20 May 2022

Urban Design Hearing Statement

The proposal comprises the removal of an existing two storey residential building containing two residential units (one on the lower level and the other on the upper level) at 292 Main Road, Tawa. The site is located on the corner of Main Road and McLellan Street, with public open space to the south of the site and a steep vegetated bank to the west, both of which are physically separated from the site by McLellan Street and Main Road respectively.

Figure 1: The Porirua Stream - viewed from the adjacent bridge on McLellan Street

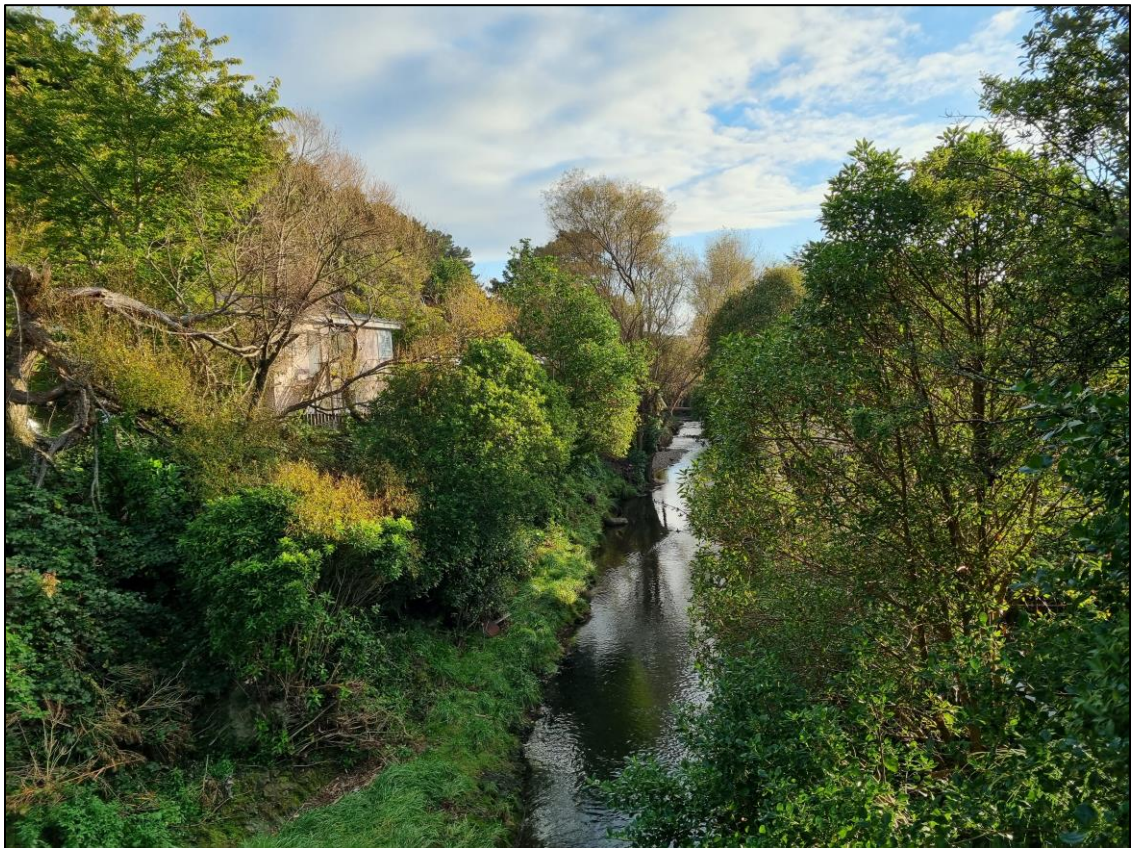
2.2 The banks of the river, within and adjacent the site, are vegetated, with a mix of grass, shrubs, and trees (refer to figure 1). Existing views from the site to the neighbouring property across the river at 1 Nathan Street are partially screened by taller trees and vegetation towards the top of the riverbank (refer to figure 2), whereas views are very open and clear to the property at 3 Nathan Street, with only grass or low-level vegetation between the application site and this neighbour (refer to figure 3). The neighbouring site to the north (292/A Main Road) is elevated above the application site and further separated by a timber fence.

Figure 2: northern elevation showing the extent of proposed building above permitted height limits

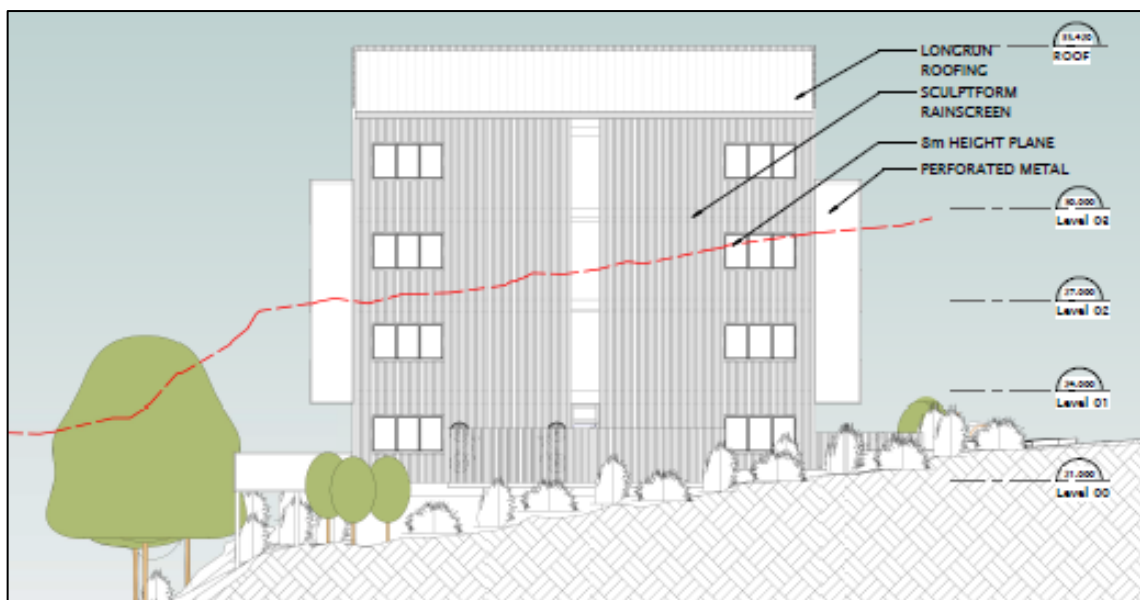
- 5.9 The proposed building does not respond positively to the Porirua Stream, with decks that project over the upper stream bank and the resulting loss of existing vegetation.
- 5.10 Dwellings in the area were predominantly constructed in the 1950s and 1960s (including the existing dwelling on the application site) and comprise timber weatherboard cladding, asbestos-cement, and/or brick veneer.
- 5.11 At four storeys in height, the proposed development will be significantly taller than the single storey dwellings on adjacent properties. The proposal will exceed the permitted height limit by one storey for the majority of the building, and two storeys in part along the northern elevation (refer to figure 4).

15.2.1 Reduce the height of the building to prevent unreasonable shading of 1, 3 and 5 Nathan Street and overlooking of 1 and 3 Nathan Street, and 292A Main Road. Provide shading diagrams to demonstrate that this has been achieved. Reducing the building height (which may include stepping down the building towards the northern boundary), will also lessen overlooking and loss of privacy for neighbouring properties.

Figure 7: section through Unit 1.01 showing relationship to the street

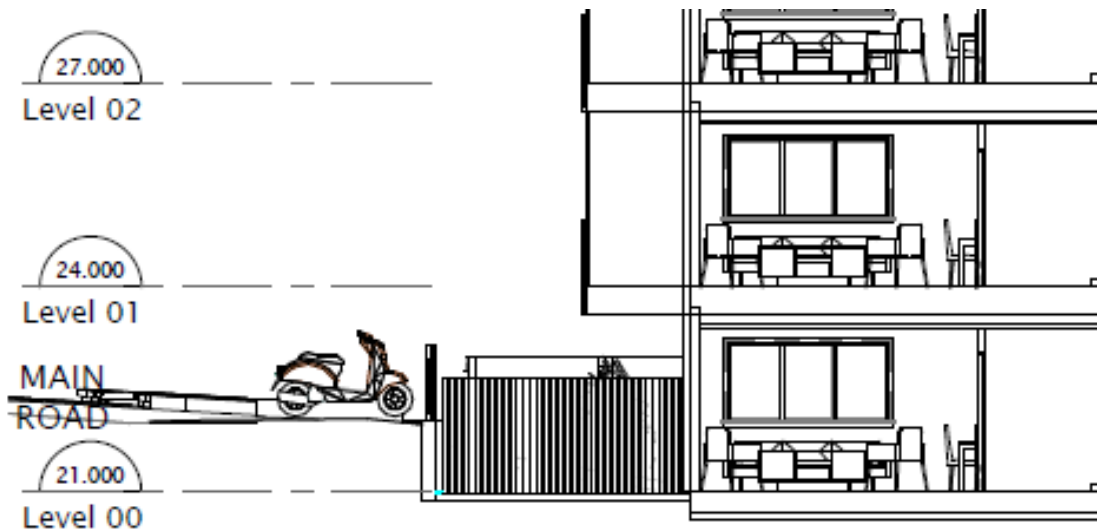
The two west facing, ground level outdoor living areas are concreted patios, with vegetation and a timber fence between the two patios to provide visual and physical separation (noting all vegetation will be on the side of the fence that services Unit 1.01, with no landscaping in the outdoor living area for Unit 1.03). These outdoor areas will be approximately 1.2m lower than the front boundary with an additional low-level fence along the top of the retaining walls (refer to figure 7). The architectural renders show these balustrades as being aluminium pool fencing, however the landscaping plans has labelled this as perforated steel. Aluminium pool fencing is likely to provide inadequate privacy from the street to both the outdoor living areas and the internal living spaces as pedestrians will be looking down into these spaces, whereas perforated steel panels will provide more privacy but are likely to limit sunlight access, especially to internal living spaces. This will be further exacerbated by upper-level decks positioned above the main access ground level threshold between internal and outdoor living areas. In conclusion, the outdoor living area for Unit 1.01 and 1.03 is considered to not provide sufficient residential amenity for occupants and does not achieve Objective 4.1 of the Residential Design Guide.

- 13.3 Unit 1.01 has the benefit of a north facing window on the northern elevation to provide additional sunlight to the internal living area; however, Unit 1.03 will not only have a triangular outdoor living area that will limit its useability due to the irregular shape, but it will not have access to any other opportunities for additional natural lighting.

15.2.2 Improve residential amenity for Units 1.01 and 1.03. This could be achieved by reducing these units to one bedroom units (which require less outdoor amenity) and increasing living room sizes and orientation. Additional windows can be utilised to achieve more sunlight and daylight to the main living areas. Alternatively, these units can be removed and the space used for other purposes such as storage lockers and bikes.
